PIC16F630/676 Rev. A Silicon/Data Sheet Errata

The PIC16F630/676 parts you have received conform functionally to the Device Data Sheet (DS40039E), except for the anomalies described below.

Clarifications/Corrections to the Data Sheet:

16-Lead Plastic Quad Flat, No Lead Package (ML) – 4x4x0.9 mm Body [QFN]

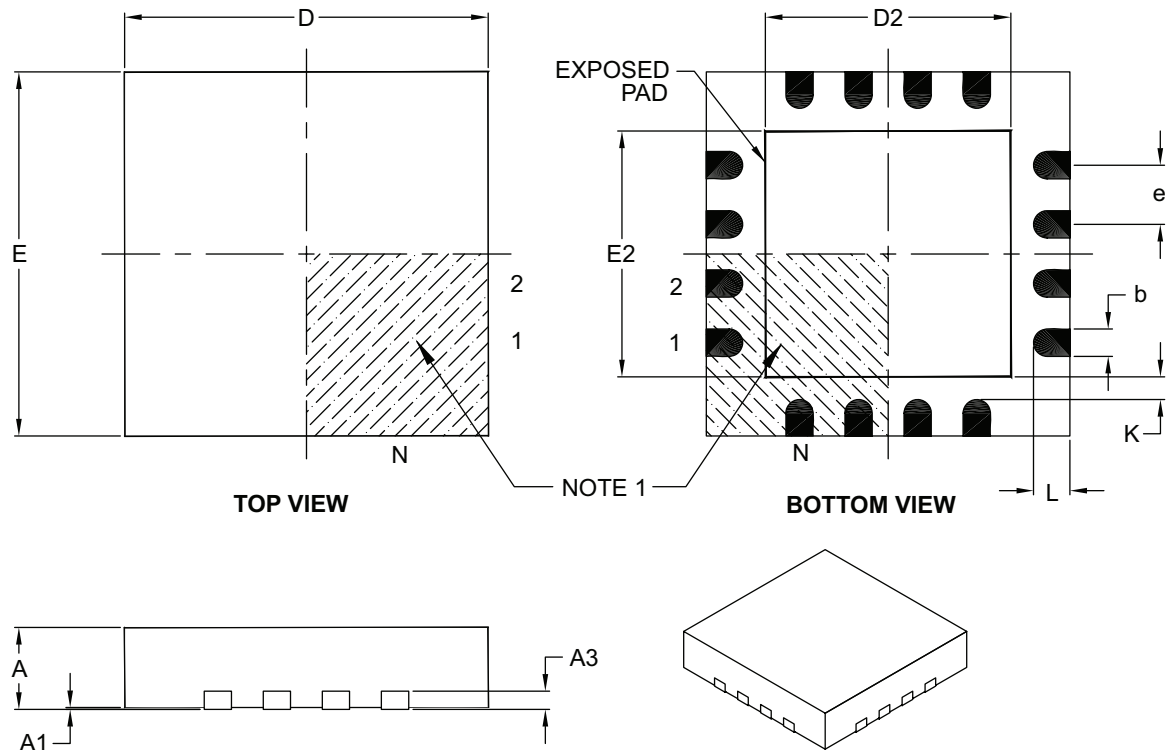
4. Module: New 4x4 QFN Package Added

The new 16-pin 4x4 QFN pinout diagrams will be added to the Pin Diagrams figure on page 2 and the Packaging Information chapter as shown below:

Dimension Limits	Units	MILLIMETERS		
		MIN	NOM	MAX
Number of Pins	N	16		
Pitch	e	0.65 BSC		
Overall Height	A	0.80	0.90	1.00
Standoff	A1	0.00	0.02	0.05
Contact Thickness	A3	0.20 REF		
Overall Width	E	4.00 BSC		
Exposed Pad Width	E2	2.50	2.65	2.80
Overall Length	D	4.00 BSC		
Exposed Pad Length	D2	2.50	2.65	2.80
Contact Width	b	0.25	0.30	0.35
Contact Length	L	0.30	0.40	0.50
Contact-to-Exposed Pad	K	0.20	–	–
